# Pflugerville Planning and Zoning Commission **AGENDA REPORT**

<b>Planning and Zoning:</b>	8/6/2018	<b>Staff Contact:</b>	Abigail Rose, Planner II
<b>Agenda Item:</b>	2018-6948	<b>E-mail:</b>	abbeyr@pflugervilletx.gov
<b>Case No.</b>	ARB1806-01	<b>Phone:</b>	512-990-6306

**SUBJECT:** Discuss and consider an application for an Architectural Waiver to allow for an increase of accent materials permitted for a structure located within the Corridor Urban Level 4 (CL4) district. (ARB1806-01)

### **PROPOSED ARCHITECTURAL DESIGN:**

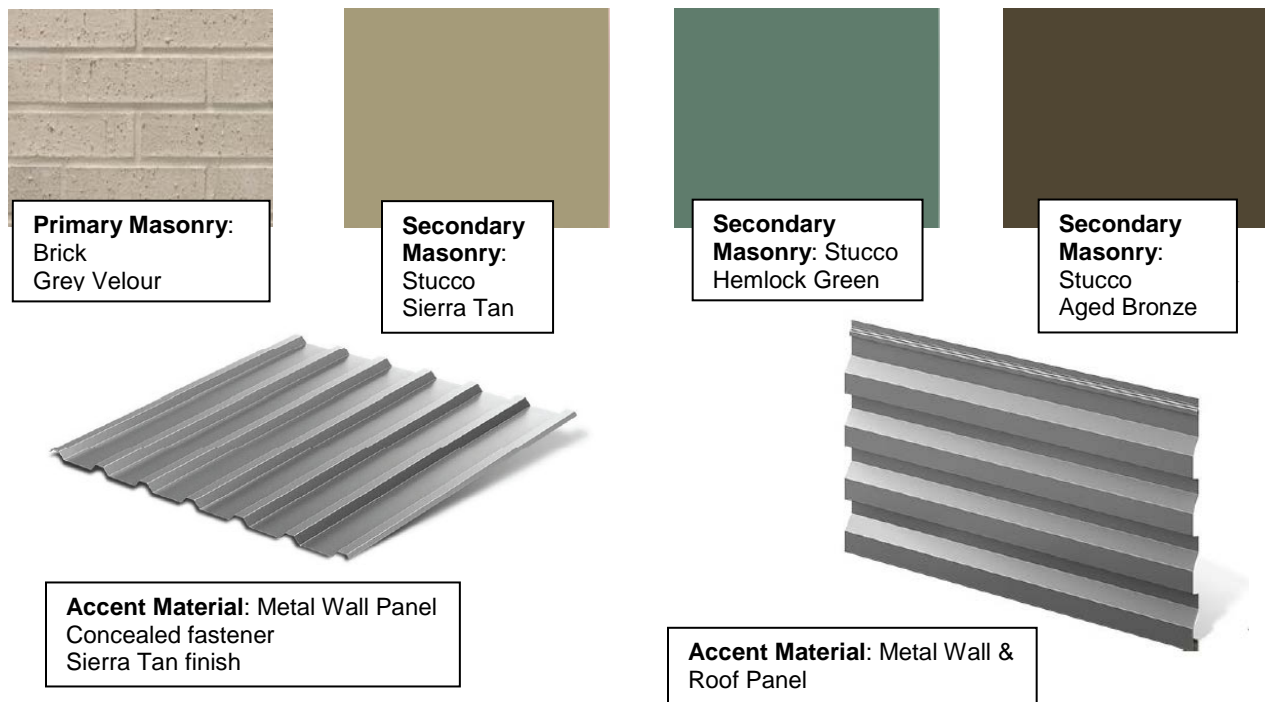
The Applicant is proposing the structure's material breakdown to consist of a total utilization of 32.5% of accent materials, when the Unified Development Code (UDC) allows for a maximum of 15%. The proposal would include an increase of allowance metal panels on the northern, western, and southern façade. The proposal asks for the doubling of the accent material allowance, while still adhering to the minimum primary masonry requirement of 40%.

The proposed architectural design meets the intent of the Unified Development Code (UDC) in terms of providing the following objectives: a mixture of building materials on the exterior building facades; horizontal and vertical articulation; and architectural details. Staff recognizes the design intentions of the project, which respond to the fast-growing SH-45 and N. Heatherwilde Blvd. greater area. The proposed structure does meet the requirement of the minimum 40% primary masonry. The eastern façade facing Highland Park Elementary is compliant with the permitted accent materials, while the northern, western, and southern facades which will abutt new developments or N. Heatherwilde Blvd. request to double the permitted accent materials. Staff finds the utilization of the metal panels appropriate for N. Heatherwilde Blvd. and the overall trend of the area.

At this time, we have three (3) architecture waivers located in the SH-45 and N. Heatherwilde Blvd. greater area. As future developments emerge in the area, Pflugerville can observe the architectural trends of the City and react accordingly. Currently, Staff has recognized the trend for the utilization of accent materials, specifically metal. Metal designs can achieve a sleek, contemporary look while also providing longevity.

Staff recommends the approval of the proposed architectural waiver to allow for an increase of accent materials permitted for a structure located within the Corridor Urban Level 4 (CL4) district.
